T ECHNICAL INFORMATION

64010

- Subject** ▶ Change of Helical Gear 43 Complete and Helical Gear 12
- For Models** ▶ 9403, 9921
- Country** ▶ All countries
- Description** ▶ Helical Gears in subject have been modified in order to increase their durabilities. To distinguish the new items from the current ones, see the information as below.

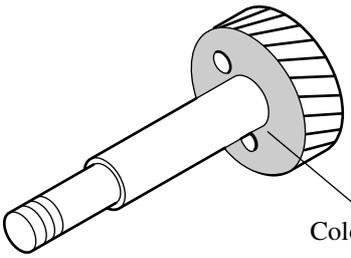
▶ Current	▶ New
 <p>Color: Silver</p> <p>Helical Gear 43 Complete (153265-4)</p>	<p>Induction Hardening has been added in its manufacturing process.</p>  <p>Color: Black</p> <p>Helical Gear 43 Complete (153291-3)</p>
 <p>No groove</p> <p>Helical Gear 12 (226506-2)</p>	<p>It has been replaced by harder one.</p>  <p>A groove</p> <p>Helical Gear 12 (226551-7)</p>

Item No.	Current part		Q'ty	I/C	New part		Q'ty	Note
041	Helical Gear 43 Complete 153265-4		1	No	Helical Gear 43 Complete 153291-3		1	Interchangeable as a set
064	Helical Gear 12 226506-2		1	No	Helical Gear 12 226551-7		1
